Inspection of Automatic Sprinkler System

CE1 Linde & Wiemann East London
Industrial Development Zone

Document No

UNC.8479

Photo 10

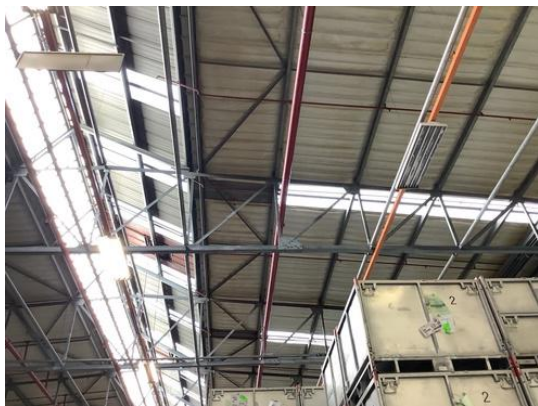
ENCLOSED PAINT LINES, DRYING OVENS AND DRYING ENCLOSURES

Sprinkler protection must be provided inside the above structures, sidewall sprinklers, (see para. 3400), may be used for this purpose.
